TRURO LIBRARY PROJECT

Library Board Assessment of the Hat Factory (HF) and Normal College (NC) Proposals for the Truro Branch Library and Regional Headquarters August 7, 2013

Example of NC broad-strokes concept on **main floor**:

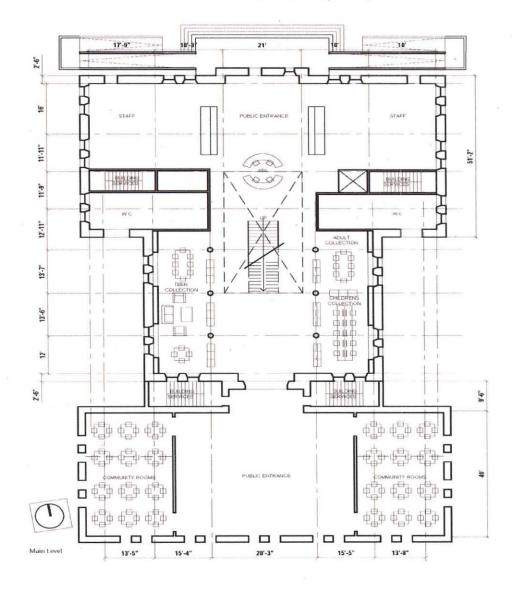
No provision for kitchenettes in/near the community rooms.

Adjacent washrooms also needed for after-hours use of rooms

Example of NC broad-strokes concept on **second level**:

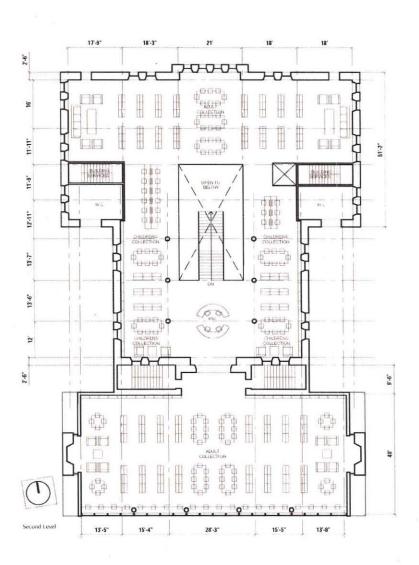
No provision for quiet/group study rooms and staff work room on this level.

Location of the children's program room (mentioned in the text) is not noted on the plan.

Location of children's area not ideal; e.g. near open stairwell, divides adult areas, forces all adults to travel through children's section.

Example of NC broad-strokes concept in **basement**:

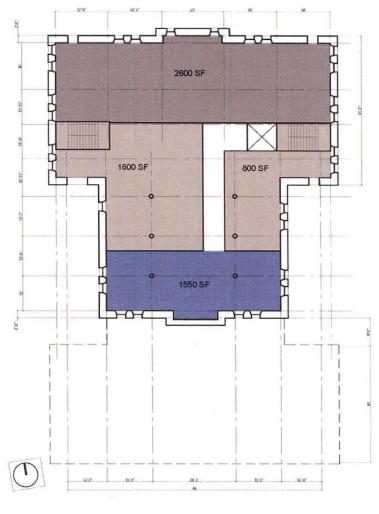
IT training/study room (1550sf area) in the basement is too isolated from the rest of the public service areas; needs to be on the main or second level with half glass interior walls, to provide site lines from the staff service desk.

Vacated basement space could be used for the staff lunch room/locker area (not shown in concept) and a meeting room for staff working groups

Example of NC broad-strokes concept on **top floor** (designated for regional headquarters).

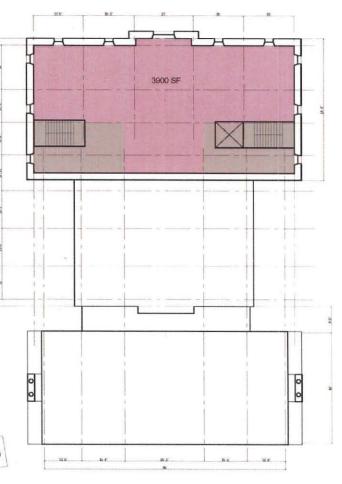
What is the usable space? Is there enough room to accommodate 13 employees, 5 offices, several workstations, an IT repair/maintenance area, open work space for receiving, processing and shipping operations, and a washroom?

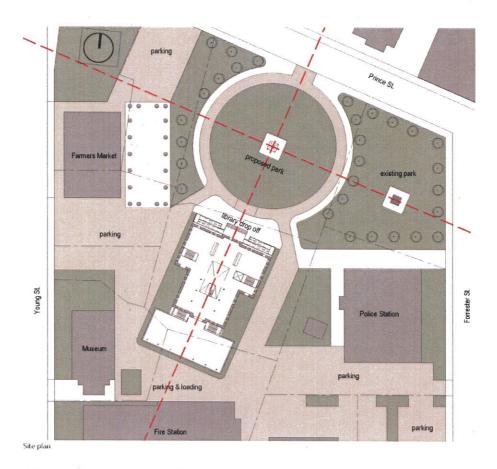
Parking in the Civic Block area is already an issue, and the proposed expansion would eliminate many parking spaces.

The number of parking spots lost/gained is unclear.

Demand for parking will increase with a larger library.
